CONTAINMENT ISOLATION VALVES

McGuire - Units 1 and 2

Attachment 2

Justification and Safety Evaluation

FIGURE 1

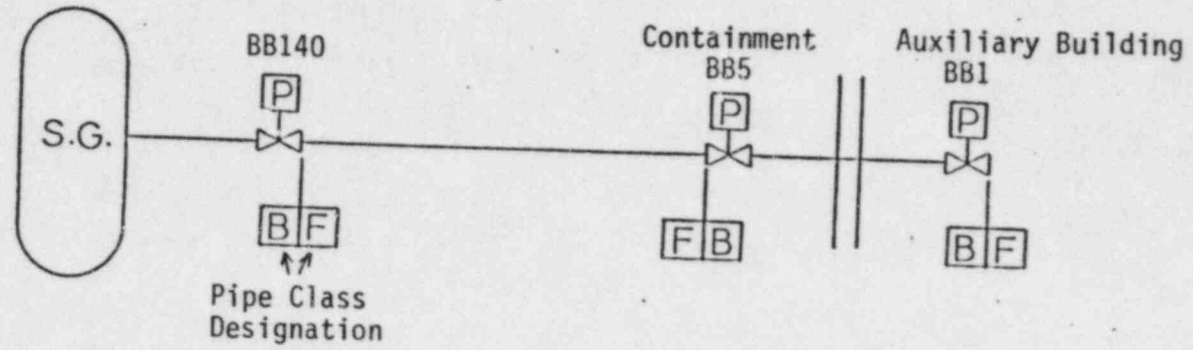
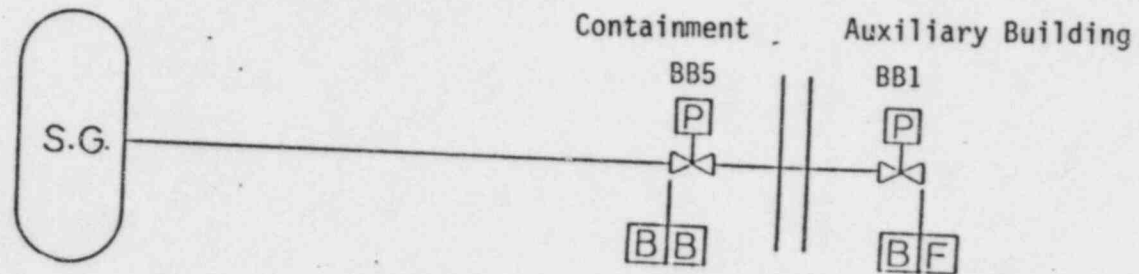
The proposed amendments would involve revising Technical Specification Table 3.6-2, Containment Isolation Valves, by deleting from the list four Steam Generator Blowdown Valves (BB140, BB141, BB142, BB143). These valves do not perform containment isolation functions and are no longer considered containment isolation valves, therefore they should be deleted from the list of containment isolation valves.

The purpose of the Steam Generator Blowdown Recycle System (BB) is to maintain acceptable steam generator shell side chemistry and to conserve the blowdown water through recycling. Each steam generator has one BB line exiting the containment, resulting in four containment penetrations for each unit. Each of these containment penetrations has containment isolation capability provided by valves BB1 through BB4 on the Auxiliary Building side and valves BB5 through BB8 on the Containment Building side (see Figure 1). These valves are included in the leak test program as described in 10CFR Part 50 Appendix J.

Steam generator blowdown valves BB140 through BB143 were installed to permit pipe class changes from B to F, which were necessary to accommodate non-safety related BB subcooling heat exchangers. These valves were originally included on the Containment Isolation Valve list due to the valves preventing release of containment atmosphere through a potentially unisolated main steam isolation valve. However, due to design changes and modifications, this situation no longer exists. The determination has been made that the four steam generator blowdown valves (BB140, BB141, BB142 and BB143) are not required to perform containment isolation functions. Therefore, upon completion of a pipe class upgrade from F to B, the four valves will no longer be required to be tested as described in the Technical Specifications. Based on this evaluation, it is concluded that the proposed amendments would not have any adverse impact upon public health and safety.
